**Grand Island, Nebraska  
Grand Island WWTP  
Headworks Improvements**

**City Project WWTP-2013-1  
B&V PN 175144  
OA PN 011-2347**

**ADDENDUM NO. 1  
April 18, 2013**

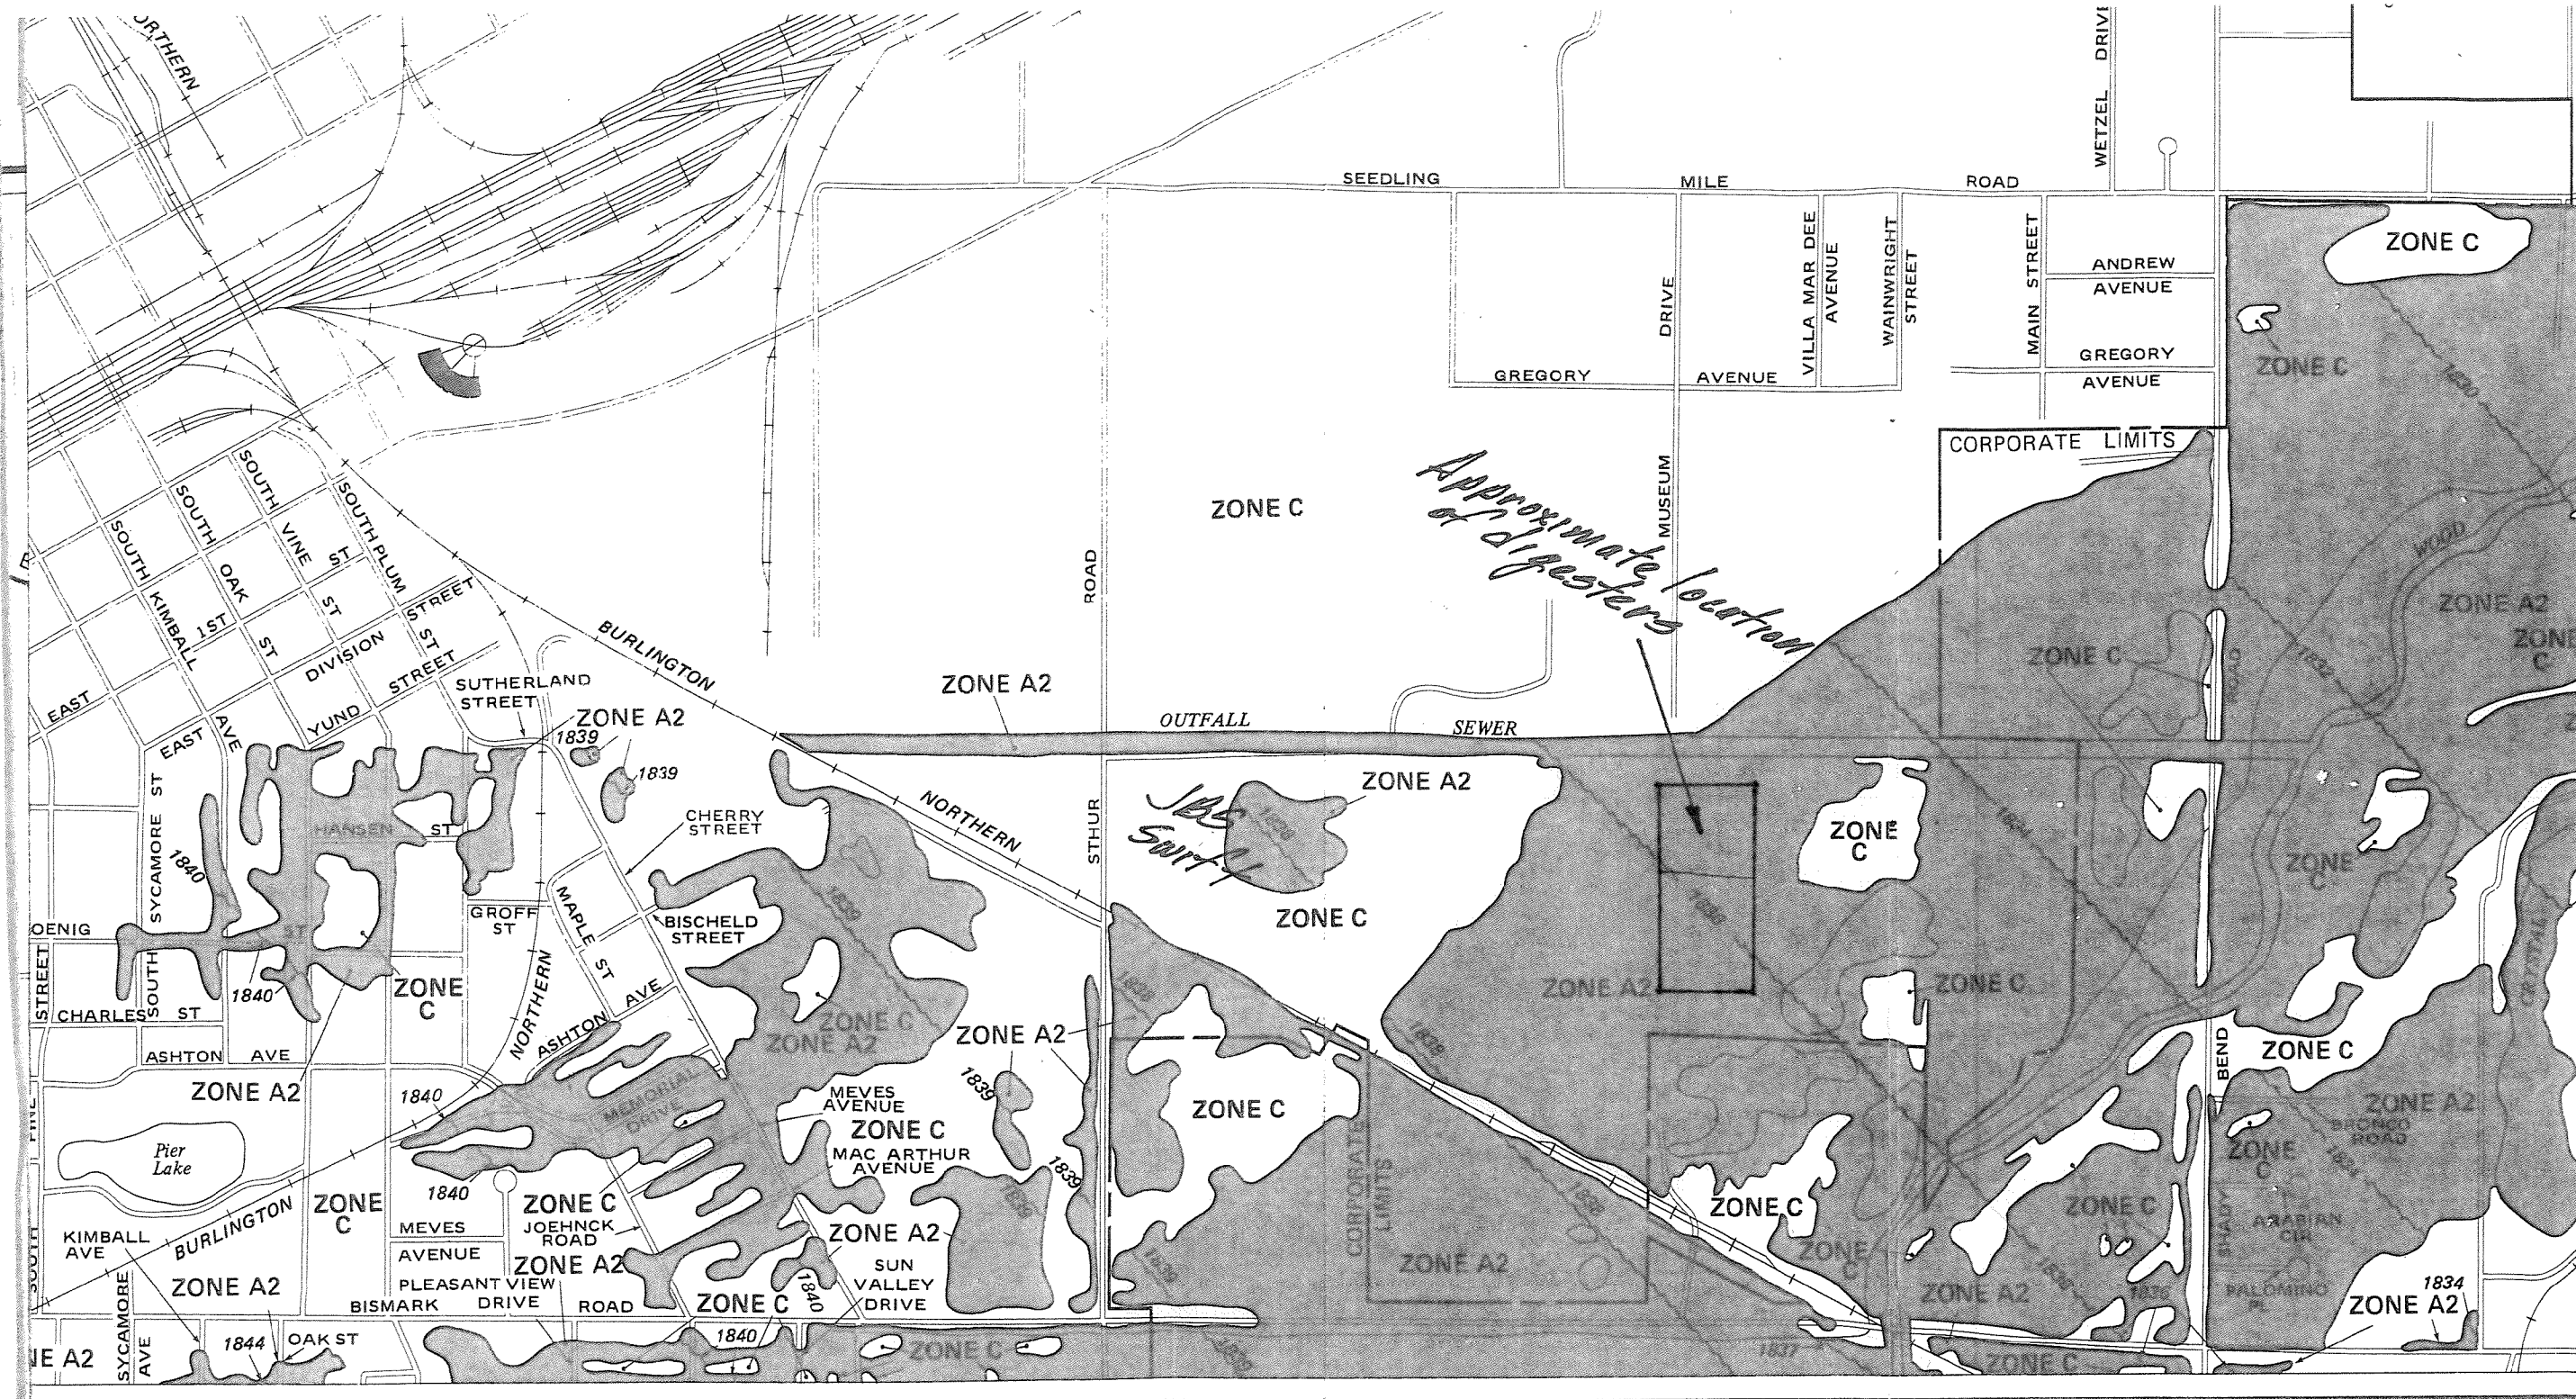
5. Flood Plain. Question: The builder's Risk insurance lists "flood" as a peril or cause of loss, in which flood plain does this project lie?

Answer: The WWTP site is in the Wood River Flood Zone A2. See the attached “WWTP Flood Plain” for additional information.
